File No: 39T-13502 / OZ-8147

то:	CHAIR AND MEMBERS PLANNING AND ENVIRONMENT COMMITTEE
FROM:	GEORGE KOTSIFAS, P. ENG. MANAGING DIRECTOR, DEVELOPMENT & COMPLIANCE SERVICES and CHIEF BUILDING OFFICIAL
SUBJECT:	APPLICATION BY: THAMES VILLAGE JOINT VENTURE CORPORATION 1691 HAMILTON ROAD APPLICATION FOR APPROVAL OF DRAFT PLAN OF SUBDIVISION OFFICIAL PLAN AND ZONING BY-LAW AMENDMENTS PUBLIC PARTICIPATION MEETING ON JUNE 20, 2016

The purpose and effect is to recommend that the Approval Authority for the City of London issue draft approval of the proposed plan of subdivision, subject to conditions and red-line revisions; and Municipal Council approve the recommended Official Plan and Zoning By-law amendments.

# **Proposed Draft Plan of Subdivision**

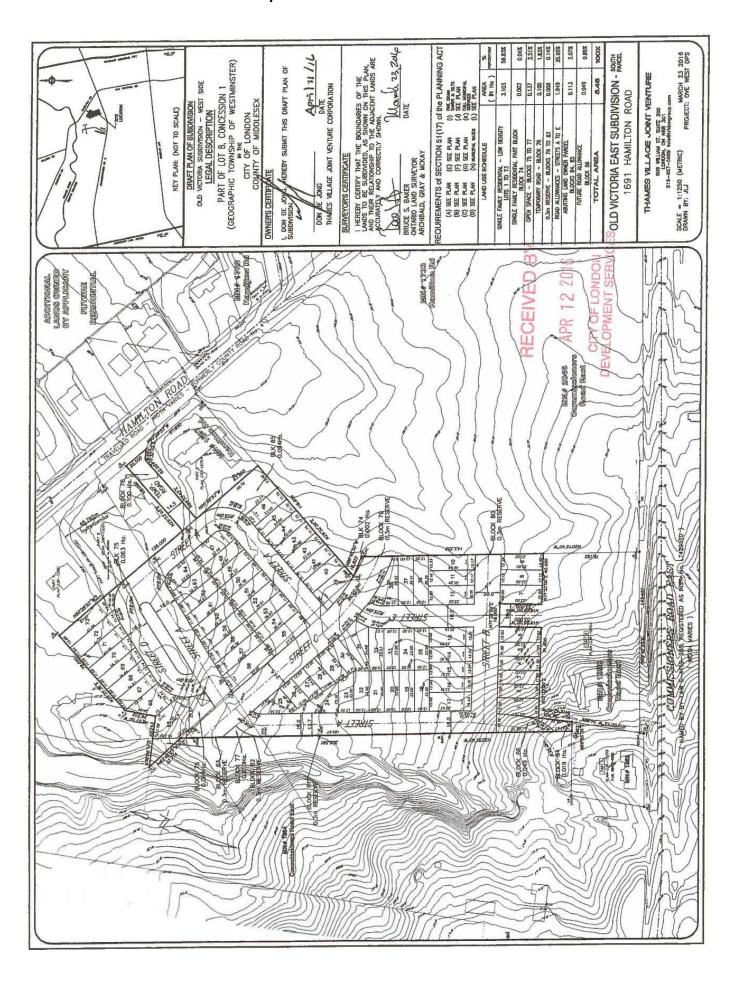
The significant red-line revision to the draft plan came about as a result of the need to shift Street 'E' further to the east in order to meet the required minimum separation distance between T-intersection locations on Street 'C'. The shifting of the road alignment triggered the reconfiguration of the lot pattern on the south side of Street 'C', and the lots within the block bounded by Streets 'A', 'B', and 'E'. The revised lot configuration provides for a better arrangement of lots fronting along Street 'C' and resolves initial concerns that some lots fronting Street 'B' would not be able to meet the minimum zoning requirements for lot area. The lots fronting Street 'A' have been reduced from approximately 12 metre to 10.5 metre frontages so there are now more lots fronting the window street. No lots have been lost as a result of the proposed red-line revisions. The angle formed by the window street and primary collector road has had a significant influence on the lot pattern, and has proved to be a challenge in the design of this subdivision. Staff recommend as a condition of draft approval, at the Design Studies stage, that conceptual building plans be prepared for the two triangular lots on Street 'A', just south of Street 'C', in order to confirm their suitability for residential building lots.

Several technical revisions have been recommended through red-line revisions to the draft plan as outlined below. Recommended draft plan red-line revisions are summarized as follows:

- Revise Street 'A' right-of-way to be minimum 19.0 metres in width south of Street 'C'.
- Minimum 40 metres between centreline of Street 'A' and the centreline of Street 'E'.
- Adjust lots to comply with Zoning By-law requirements.
- Identify Block 75 within the right-of-way.

• Revise the centreline radii of all streets (eg. Street 'E' and Street 'A') in accordance with City standards. At 'tee' intersections, the projected road centreline of the intersecting street shall intersect the through street at 90 degrees with a minimum 6 metres (20') tangent being required along the street lines of the intersecting road.

- Provide minimum of 5.5 metres (18') along the curb line between the projected property lines of irregular shaped lots around the bends on Streets 'D'.
- Adjust size of Block 76 to comply with HONI requirements, if necessary.
- Add 0.3 metre reserves along open road allowances, and north/south sides of temporary road.
- Add future road allowance block on Street 'C', west of Street 'A'.
